Quantify options for 100% fully decarbonized electric power

BRIEFING QUESTIONS & COMMENTS

Validating model variability

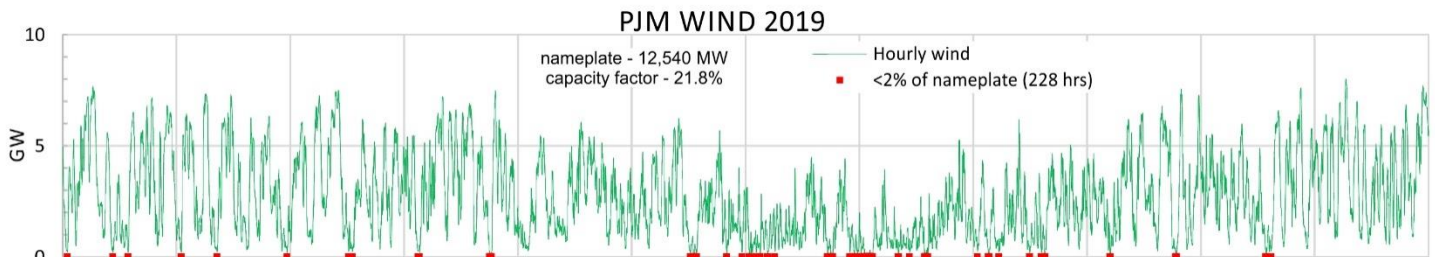
“VCE starts by recreating 2020 with existing generation and transmission as it was then...,” The chart below presents an hourly time series of total wind production on the PJM system for the year 2019. Note that total wind power on the whole PJM system dropped below 2% of nameplate (red dots) for 228 hours during 2019.

Hours-below-threshold is an important validation metric because it is the result of PJM scale weather patterns. No PJM wind means no PJM wind power no matter how many wind turbines are on the system. Based on scaling evidence, managing system wide low-wind-low-sun conditions begins to dominate total system costs when intermittent generation exceeds 20%. VCE has said that modeled profiles are smoother than actual generation. If model smoothing eliminates these 228 low wind hours, it would unrealistically overestimate wind reliability. Validating WIS:dom-P for hours-below-threshold for the base year, provides confidence that the model can fairly represent OSW.

2. Does the model reasonably represent hours-below-threshold data for the base year?
3. What are wind and solar capacity factors for the base year?
4. For new construction, how does VCE quantify real world conditions: forced outages, planned maintenance, imperfect installations, shadowing, ageing equipment, and local curtailment?
